Note Update of the Filter Defining IF1 September 20, 2005 – DRD

The filter defining the intermediate frequency (IF) 1 bandpass has now been built and tested. This note updates the RF up/down-converter scheme based on this data.

Figure 1: Bands and LO's of the RF converter board.

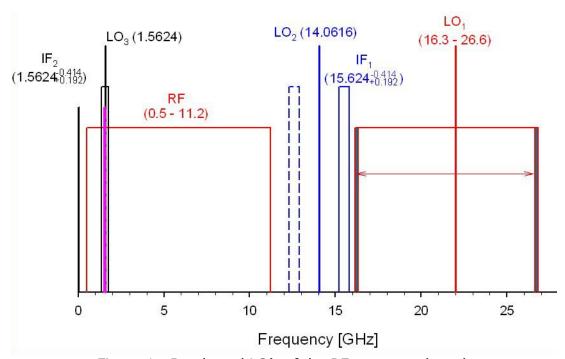
The previously defined IF1 bandpass was 15.624 GHz \pm 0.200 GHz (3dB). The filter as implemented has nominal characteristics of 15.510 \pm 0.300 GHz (3dB). Rather than change the LO frequencies, which are defined as multiples of a standard reference, the defined "center" of IF1 will remain 15.624 GHz, which is allowed by the additional bandwidth.

The following table lists various points defining the IF1 bandpass and Figure 1 defines the bands and LO's. Figure 2 is the measured bandpass filter.
